Informal document No. 12 (85th GRSG, 20 - 24 October 2003, agenda item 1))

ECONOMIC COMMISSION FOR EUROPE INLAND TRANSPORT COMMITTEE World Forum for Harmonization of Vehicle Regulations (WP.29) Working Party on General Safety Provisions (GRSG)

PROPOSAL FOR DRAFT AMENDMENTS TO REGULATION No. 36

Transmitted by the Expert from Germany

Figure 8b "Space for seated passengers behind a seat and or/or a seat facing the gangway" (see paragraph 5.7.8.5.2)

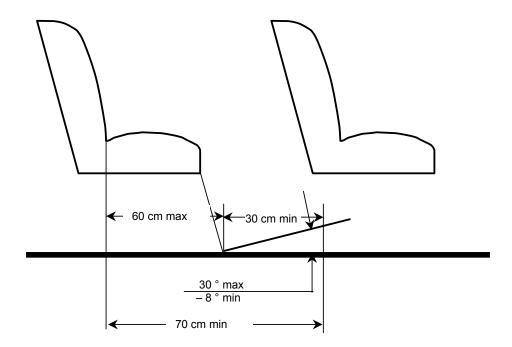
"5.7.8.5.2. For a seat behind a seat and/or a seat facing the gangway, a minimum clear foot space of at least 300 mm depth and a width according to paragraph 5.7.8.1.1., shall be provided as shown in Annex 3, figure 8b. The local presence in this space of seat legs and of intrusions as provided by paragraph 5.7.8.6.2.3 shall be permitted provided that adequate space remains for the passengers' feet. This foot space may partly be situated in and/or above the gangway but shall not create any obstruction when measuring the minimum gangway-width in accordance with paragraph 5.7.5. "

Insert a new drawing:

- 1. to clarify the interpretation of paragraph 5.7.8.5.1. and Annex 3 figure 8, which was intended not to impose any additional requirements on seat spacing but instead to determine the clear space between a passenger seat and a partition or other rigid structure other than a seat, and
- 2. to clarify that the foot space in front of each passenger seat may be so located such that parts of the foot space "intrude" into the gangway, either on the floor or above it. In any case, while measuring the gangway width with the respective testing gauge, the foot space shall not obstruct movement of the gauge.
